From:	BUS: Waste Plans
Sent:	Friday, 21 April 2023 1:57 pm
То:	Monique Zorn
Cc:	Nick Owen; Greer Francis; Andre Bishop
Subject:	RE: Response to s92 request One Tasman - WCC Query - Waste Facilities
Follow Up Flag:	Follow up
Flag Status:	Flagged

One Tasman | Pukeahu Park

Waste Management Room Summary

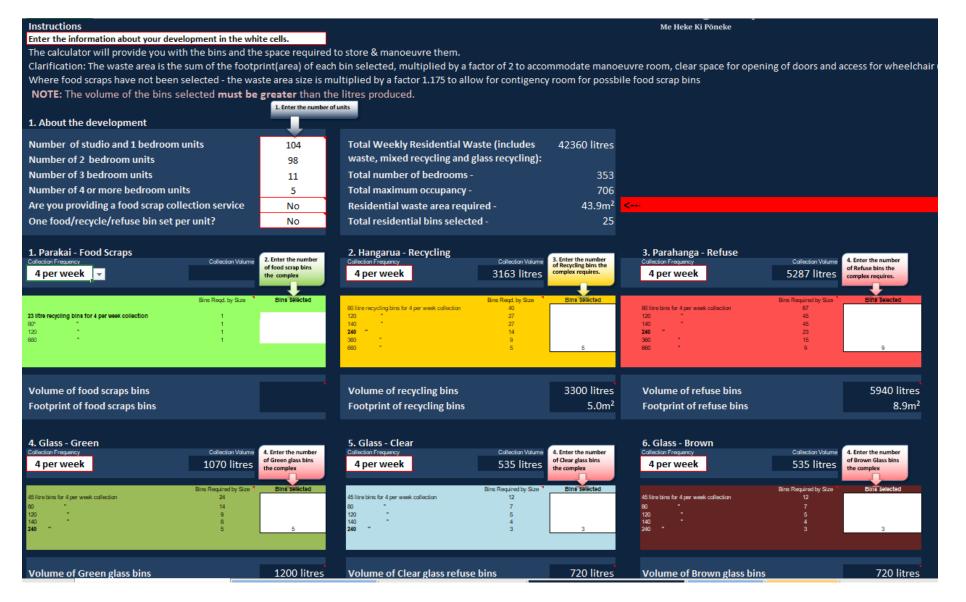
We discussed frequency of collections, and based on 4 collections a week for the proposed number of units, a waste storage area of 50m2 is adequate. I am satisfied with this high number of collections per week due to the scale of the development.

I've included a screenshot of the calculator to confirm the number of bedrooms this calculation is based on:

I have advised them that prior to construction they will need to submit a MUD Waste Plan to provide details of collections, security, accessibility etc. Further details on this can be found in the Solid Waste Management and Minimisation Bylaw 2020.
